# **Groundwater Application Review Summary Form**

#### PUBLIC INTEREST REVIEW FOR GROUNDWATER APPLICATIONS Water Rights Section Date 08/02/2017 TO: Groundwater Section \_\_\_\_\_ Dennis Orlowski FROM: Reviewer's Name SUBJECT: Application G- 18478 Supersedes review of Date of Review(s) PUBLIC INTEREST PRESUMPTION; GROUNDWATER OAR 690-310-130 (1) The Department shall presume that a proposed groundwater use will ensure the preservation of the public welfare, safety and health as described in ORS 537.525. Department staff review groundwater applications under OAR 690-310-140 to determine whether the presumption is established. OAR 690-310-140 allows the proposed use be modified or conditioned to meet the presumption criteria. This review is based upon available information and agency policies in place at the time of evaluation. Applicant's Name: Chris Gesik County: Clackamas A. GENERAL INFORMATION: Applicant(s) seek(s) <u>0.25</u> cfs from <u>one</u> well(s) in the <u>Willamette</u> Basin, A1. \_\_\_\_\_ subbasin Molalla River Proposed use Nursery (10.0 acres) Seasonality: Year round A2. Well and aquifer data (attach and number logs for existing wells; mark proposed wells as such unde

# **Stream Depletion Modeling**

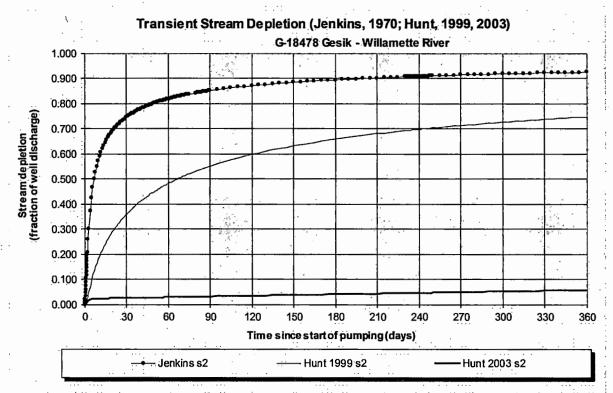
The Hunt 2003 analytical stream depletion model was used to estimate pumping interference at 30 days at SW1 (Willamette River). Model results indicate that interference is expected to be less than 25% of the maximum allocated pumping rate at 30 days.
